M-9A0 (Calpella + N11P/M Discrete Graphic)

FOXCONN		HON HAI Precision Ind. Co., Ltd.	
		CCPBG - R&D Division	
Title ARD (CLK,MISC,JTAG)			
Size	Document Number	Rev	
Custom	M9A0 MP	1.1	
Date:	Thursday, November 19, 2009	Sheet	3 of 73

FOXCONN		HON HAI Precision Ind. Co., Ltd.	
		CCPBG - R&D Division	
Title	PCH (PCI-E, SMBUS, CLK)		
Size	Document Number		Rev
Custom	M9A0 MP		1.1
Date:	Friday, October 23, 2009	Sheet	10 of 73

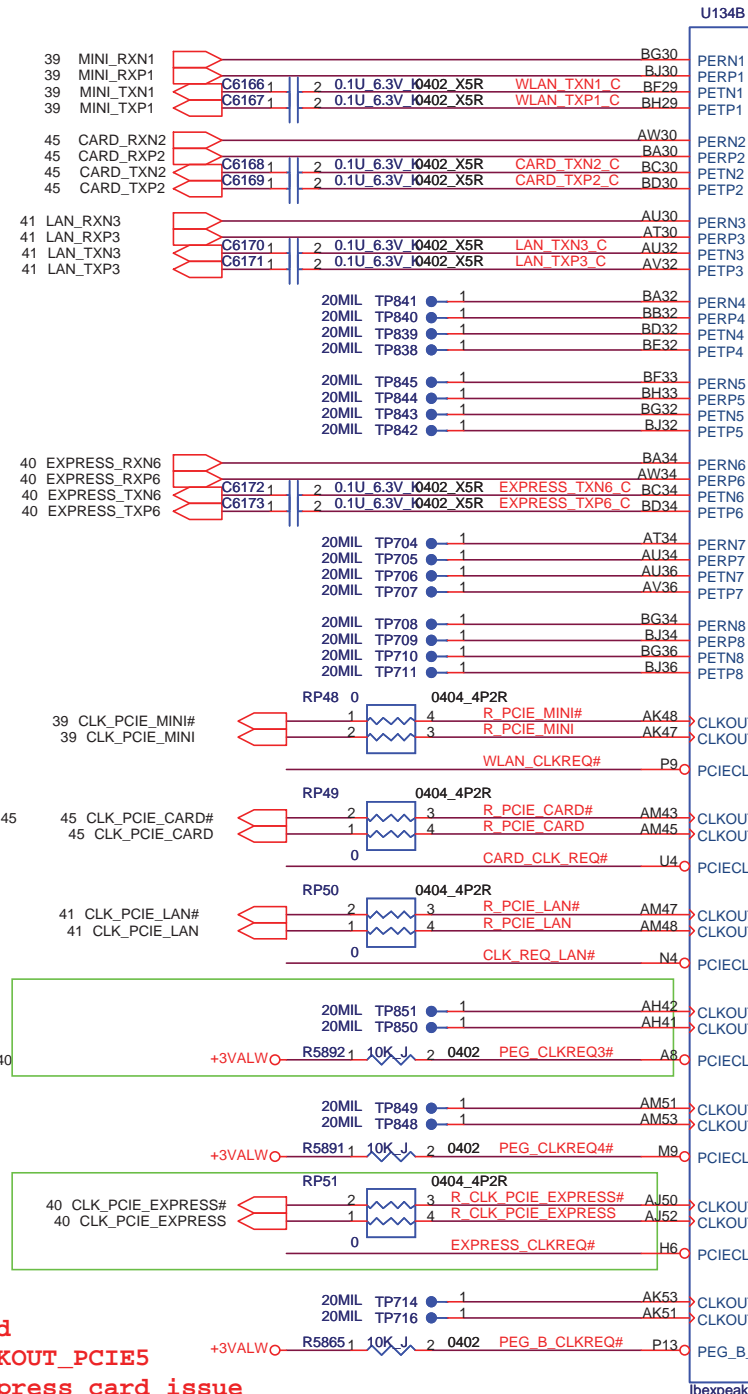
2009/09/10
 Remove PCI-E Express card
 differential clock to CLKOUT_PCIE5
 for DVT1 can't detect express card issue

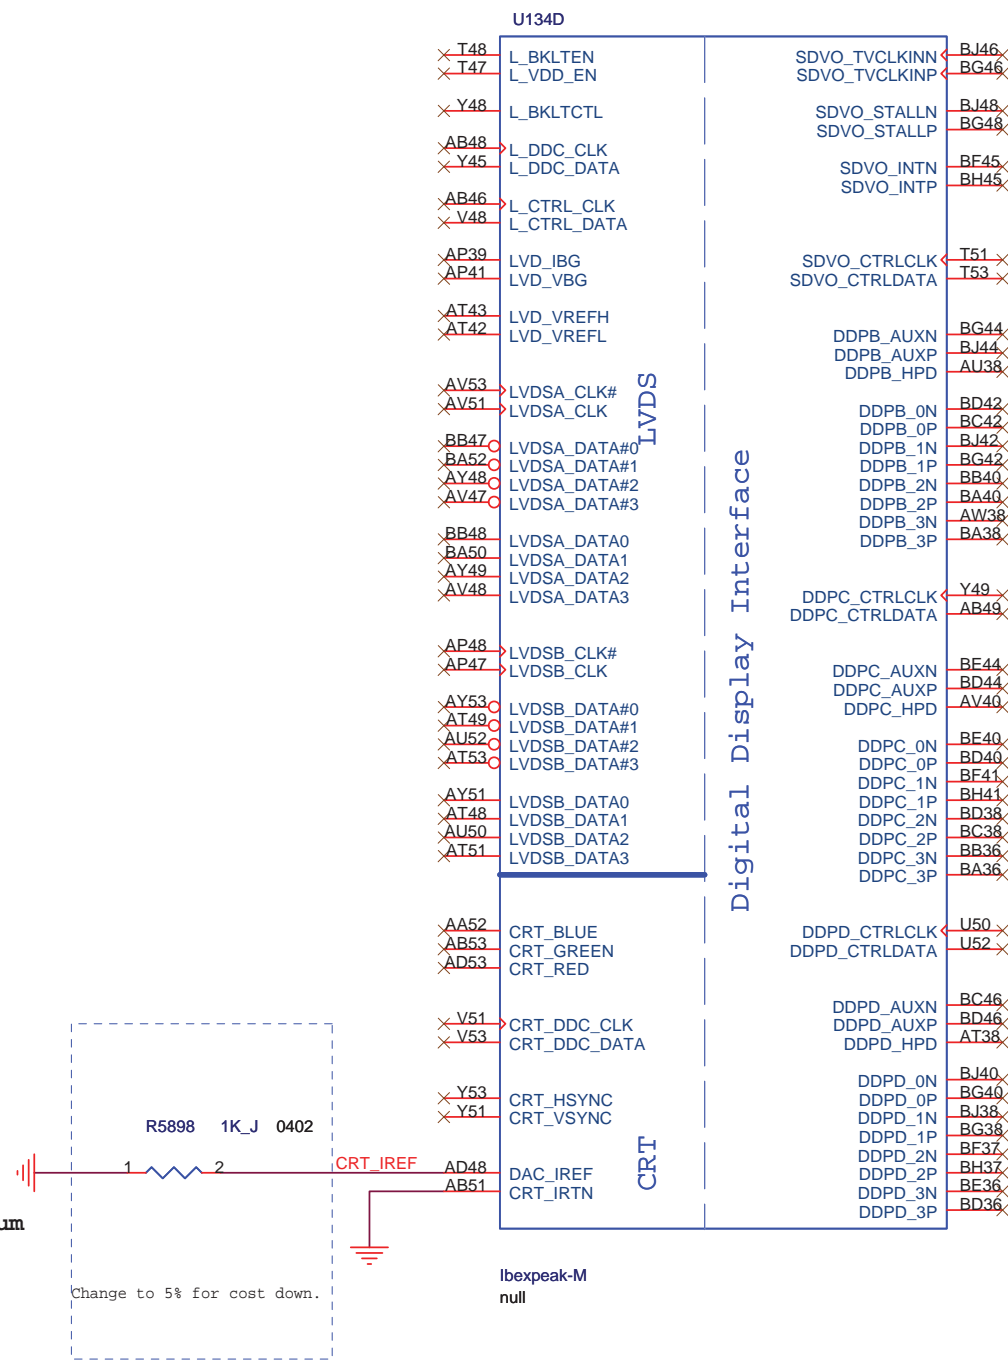
2009/09/10 (DVT2)
 Delete R5893, add R6007 to +3VALW
 M9A0 use Ignition FW, no ACPRESENT function.
 Intel FAE suggest this pin can configure it as GPIO.

2009/09/10 (DVT2)
 Delete R5887 and Net name AC_Present
 M9A0 use Ignition FW, no ACPRESENT function.
 Intel FAE suggest this pin can configure it as GPIO.

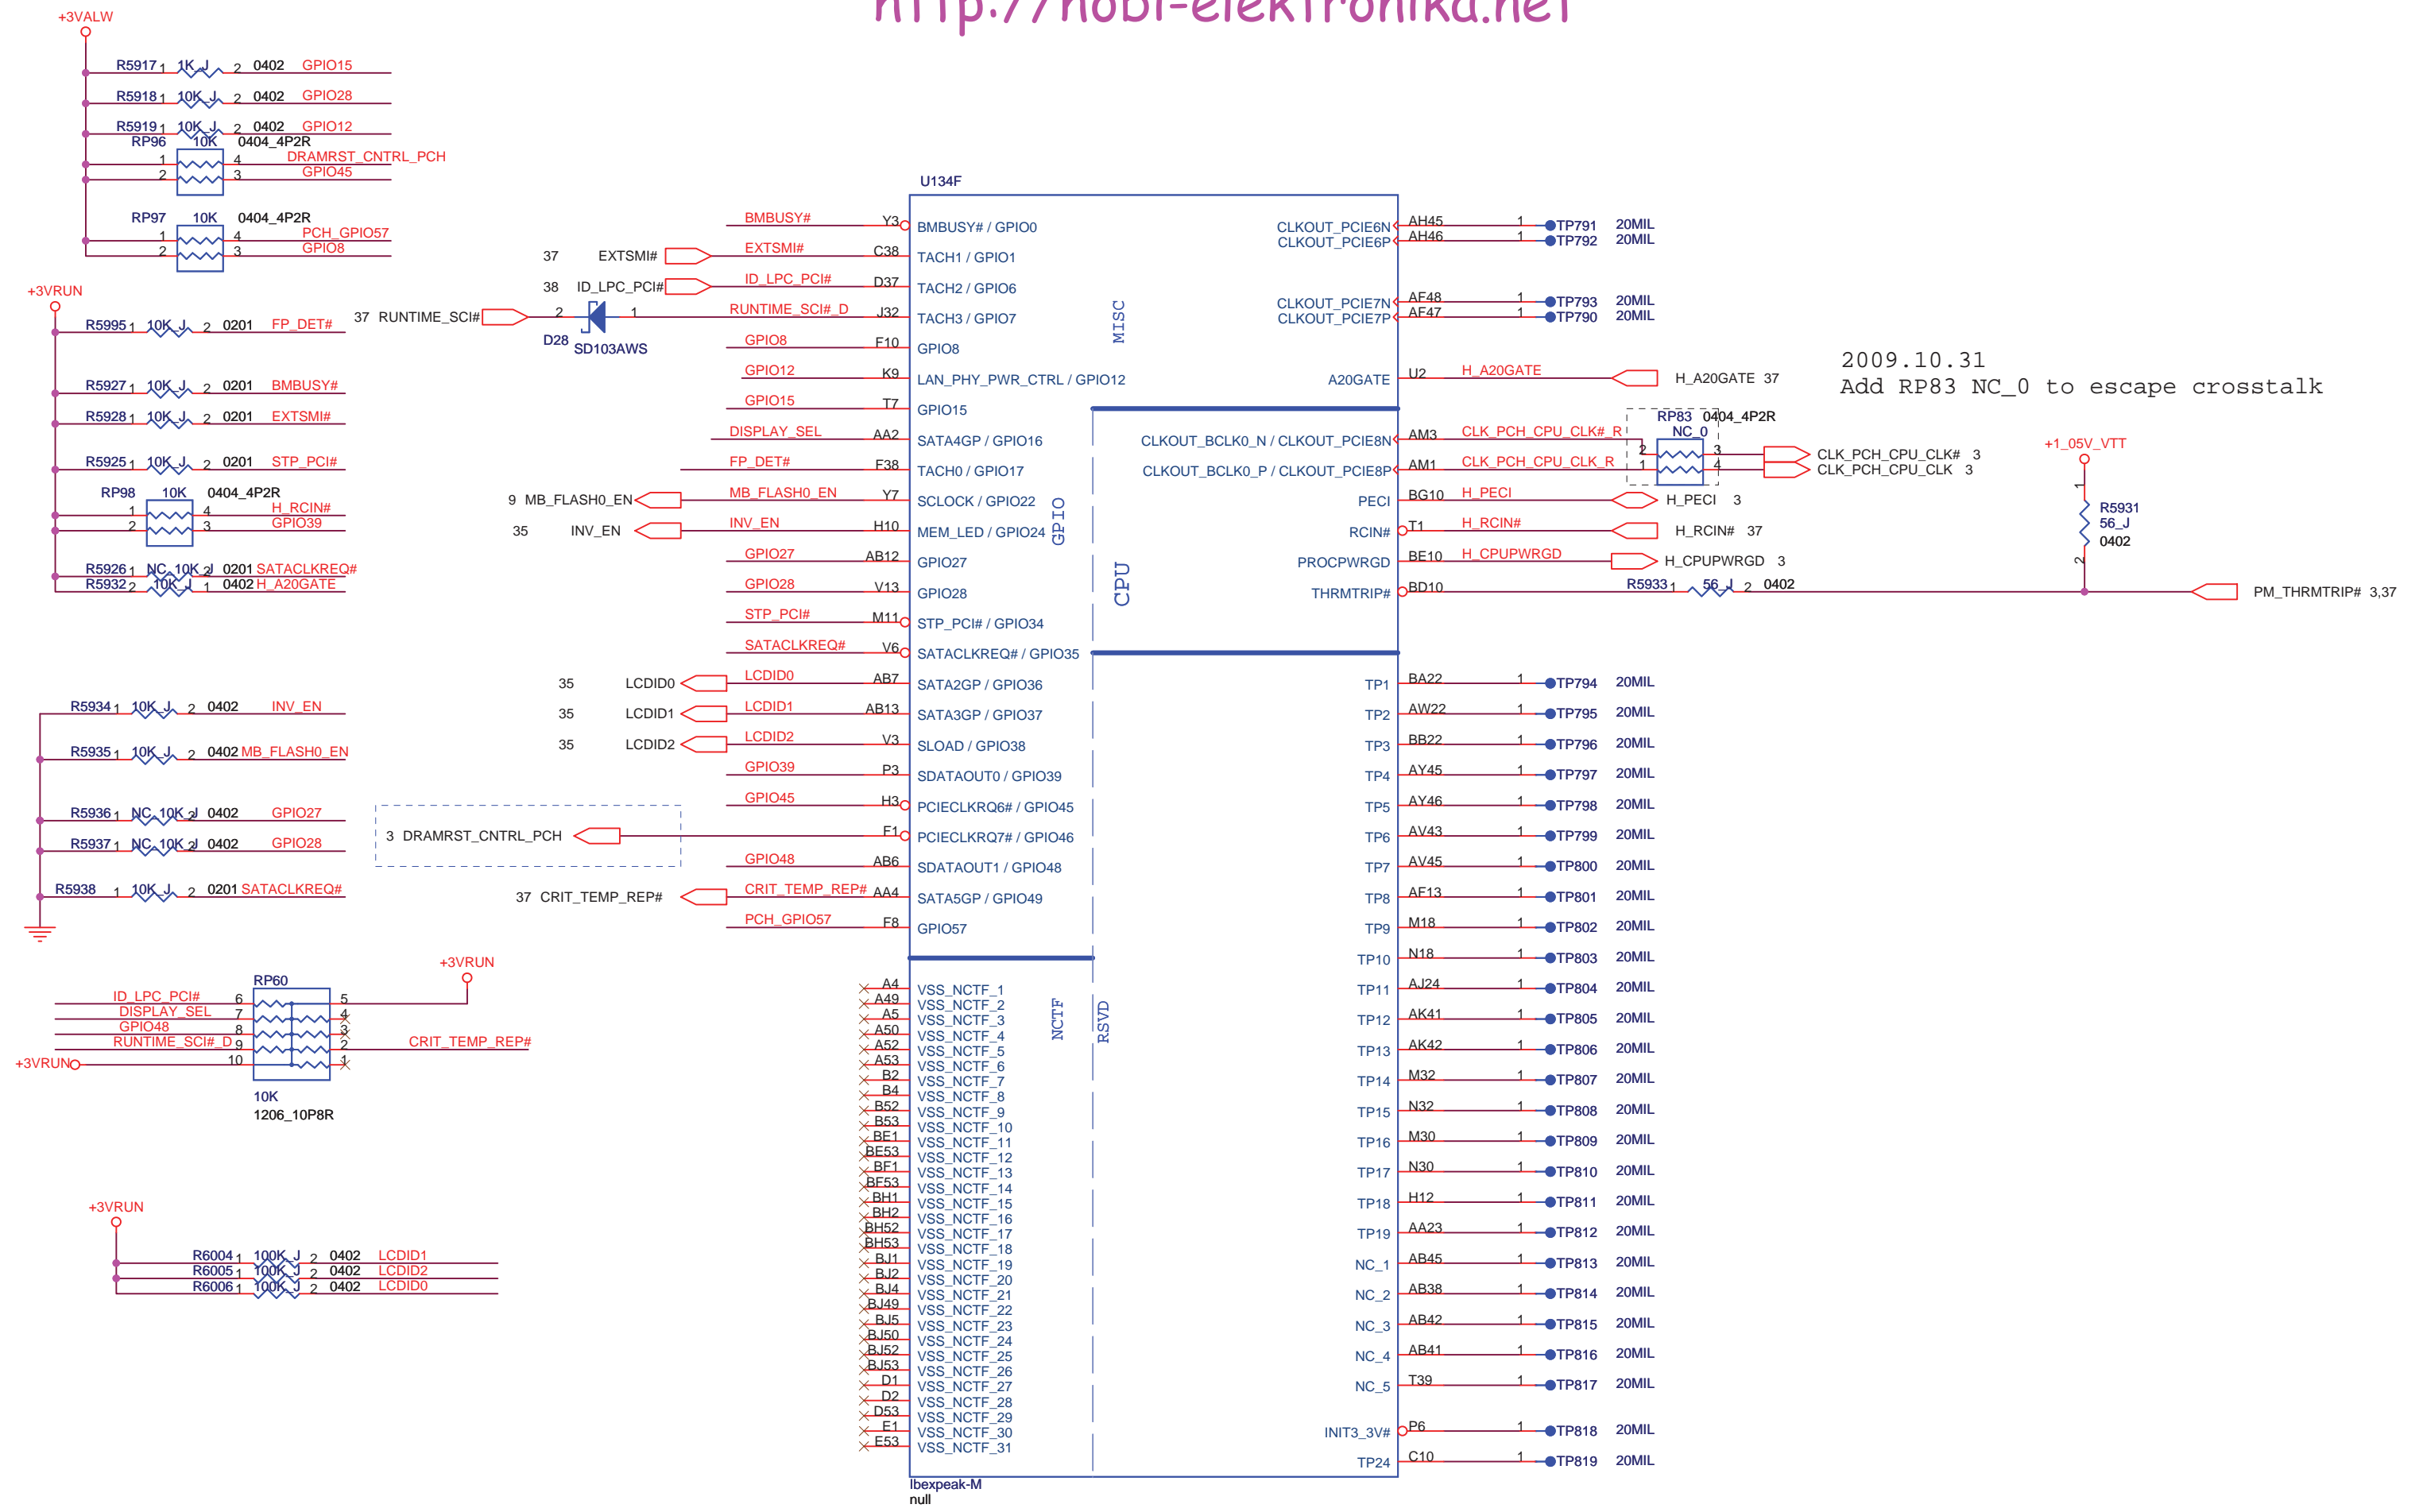
2009.10.31
Add RP83 NC_0 to escape crosstalk

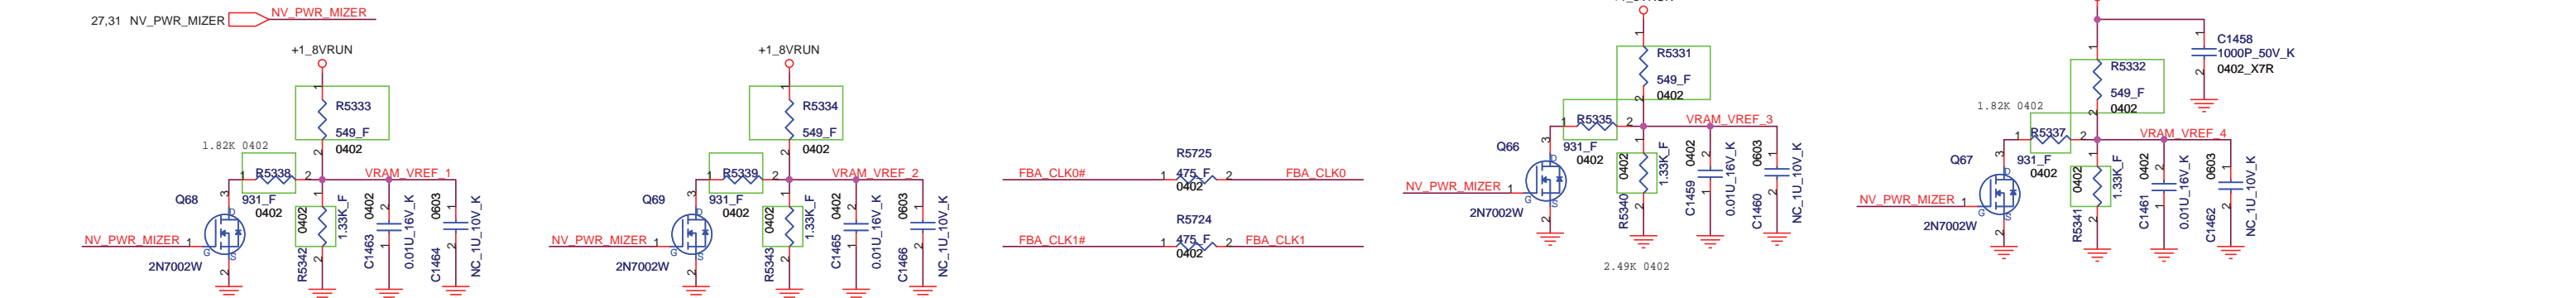
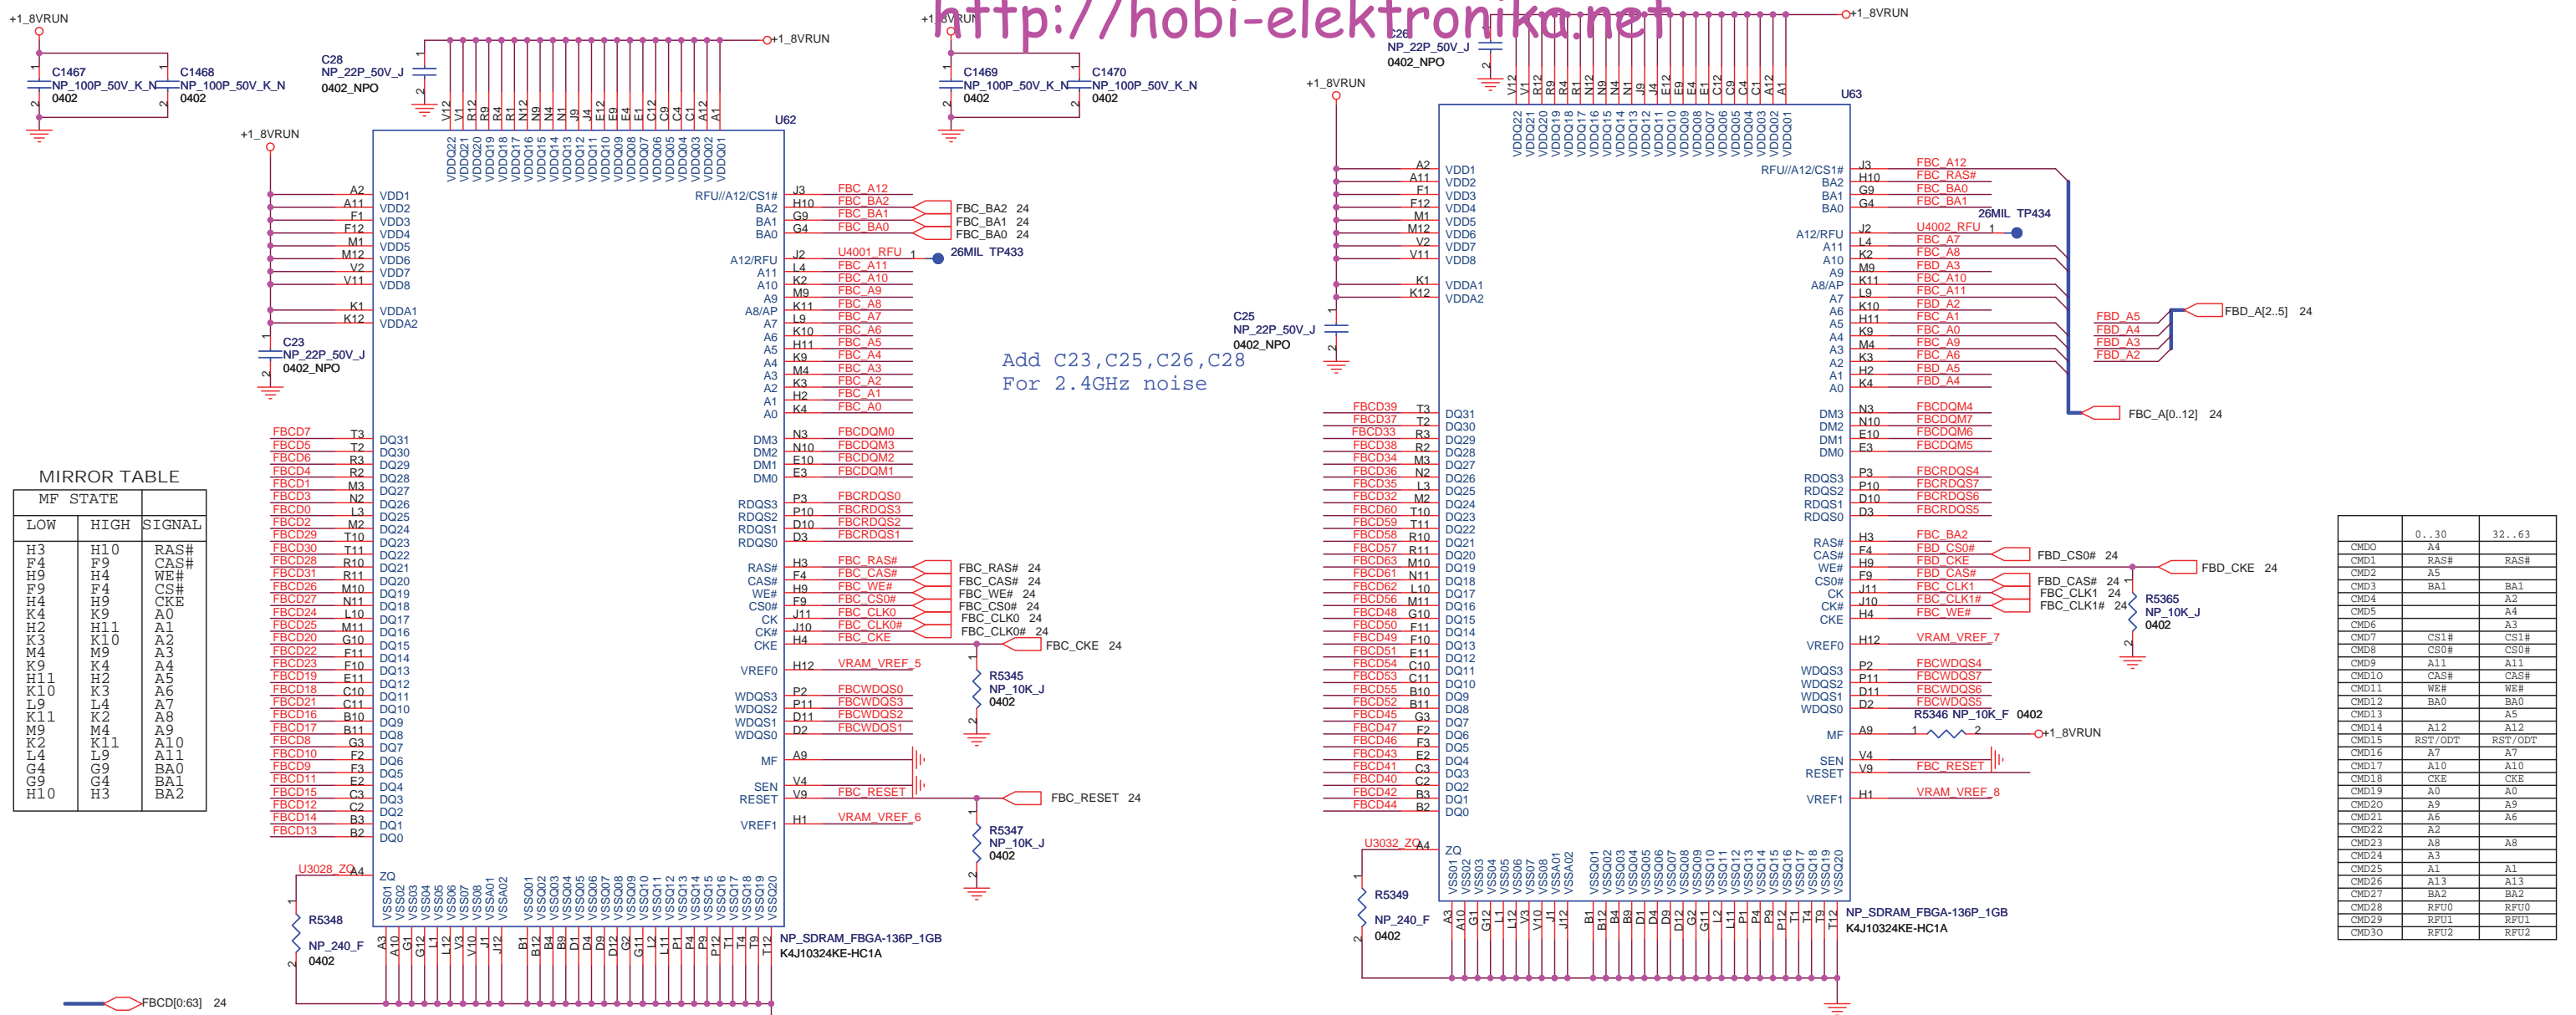
2009/9/10
 N11P-LP1+SAMSUNG(H2 SKU)
 Change R5340,R5341,R5342,R5343 from
 1R-0001331-F200(1.33K) to 1R-0000222-J200(2.2K)
 for nVIDIA FAE suggest.

2009/9/10
 N11P-LP1+SAMSUNG(H2 SKU)
 Change R5331,R5332,R5333,R5334 from
 1R-0005490-F200(549ohm) to 1R-0009310-F200(931ohm)
 for nVIDIA FAE suggest.

2009/9/10
 N11P-LP1+SANSUNG(H2 SKU)
 Change R5335,R5337,R5338,R5339 from
 1R-0009310-F200(931ohm) to 1R-0000122-F200(1.2K)
 for nVIDIA FAE suggest.

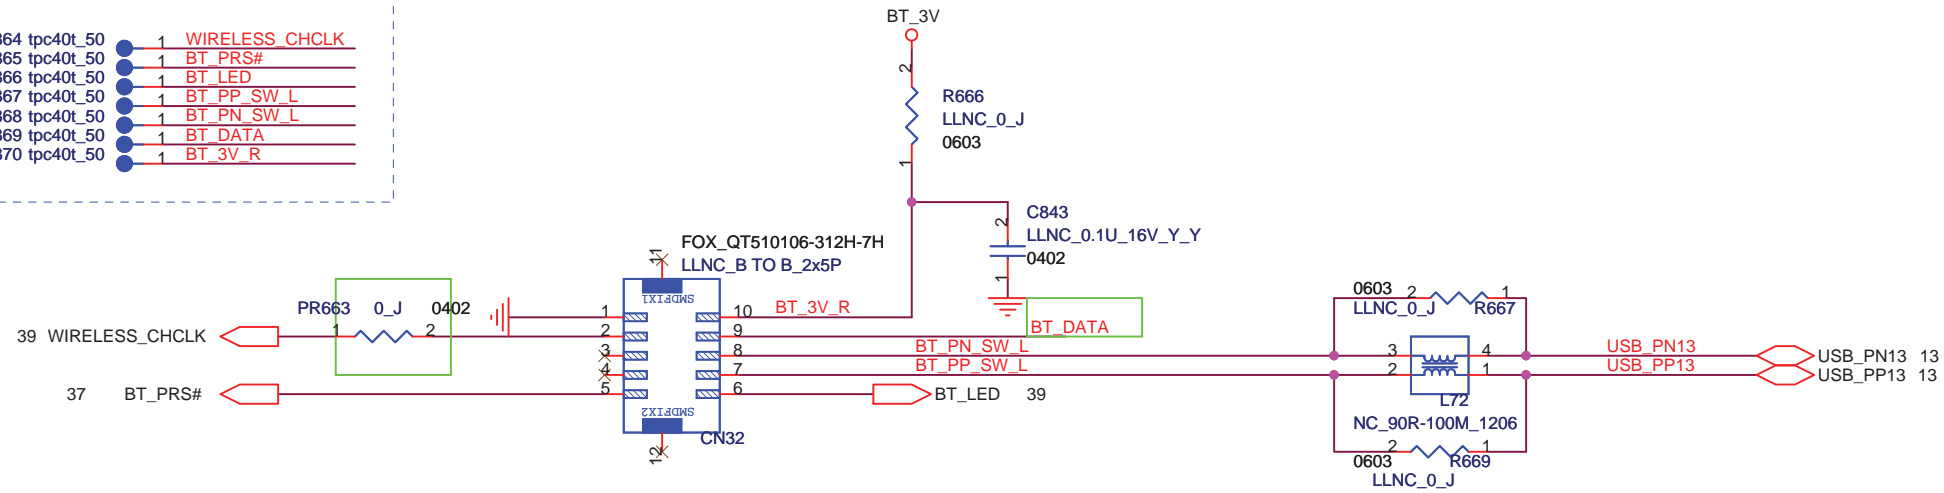
2009.0921
WIRELESS_DATA/WIRELESS_CHCLK follow M930

2009.11.19
Change R6009 from 1R-0000000-J200 to 1R-0000101-J200 for RF request
